7.1.2 TPA/54600A - 319-321 SPRINGVALE ROAD, GLEN WAVERLEY

EXECUTIVE SUMMARY

This application seeks to amend Planning Permit TPA/56400 by proposing an additional (fourth) level to the previously approved three storey medical centre. The approved development is currently under construction.

Extract from the proposed fourth storey (level 3) floor plan

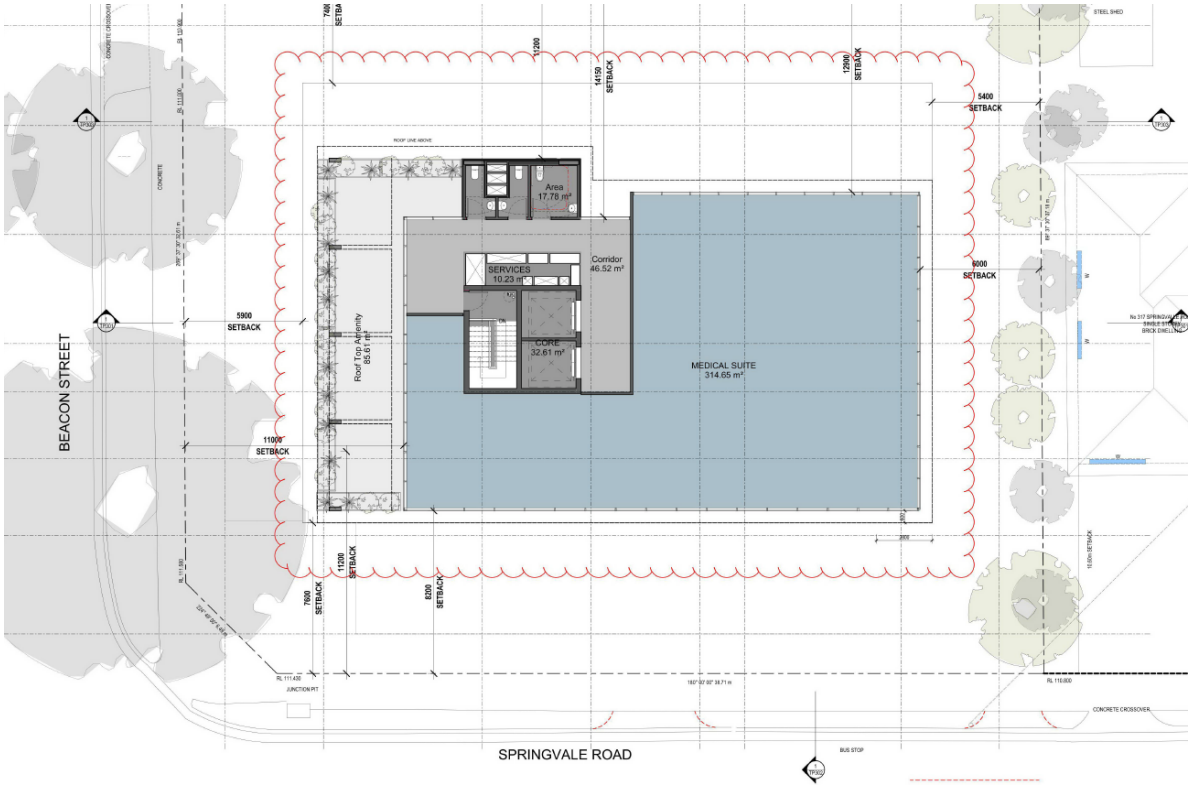
The proposed fourth storey (level 3 on the plans) setback is consistent with the approved building setbacks:

East (front) **Springvale Road**	**South** **Beacon Street**	**West (rear)**	**North**
Basement	2m	2m	4.5m	2m
Ground level	7m	2.5m	4.5m	3m
Level 1	7m	2m	4.5m	3m
Level 2	8.2m	6.5m	8m	6m
Level 3 (proposed)	8.2m	11m	11.2m	6m

Extract of approved (left) and proposed (right) cross-section development plans.

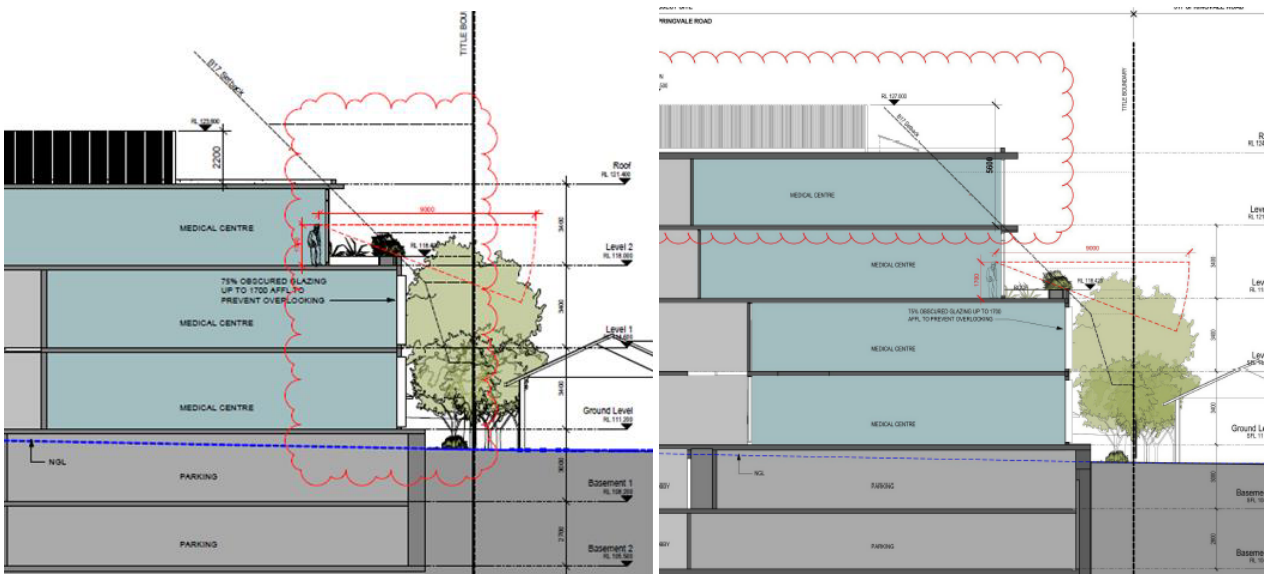
The proposed fourth level (Level 3) is provided with floor-to-ceiling clear window glazing at every orientation, and potential overlooking impacts on the adjoining residential properties to the north and west have been considered.

To the west, the building is setback more than 9 metres from the residential boundary, exceeding the separation distance generally applied in assessing overlooking impacts. As such, it is unlikely to result in unreasonable overlooking to the west adjoining residential properties.

To the north, concerns remain that the floor-to-ceiling clear glazing at the fourth storey (Level 3) may enable direct views into the secluded private open space of the adjoining dwelling at 317 Springvale Road. Given the elevated position of the floor level and lack of opportunities for landscape screening, it is recommended that the north-facing window be treated with obscure glazing to a height of 1.7 metres above finished floor level, consistent with the approved treatment on Level 1, to prevent unreasonable overlooking, this has been included in the recommended conditions above.
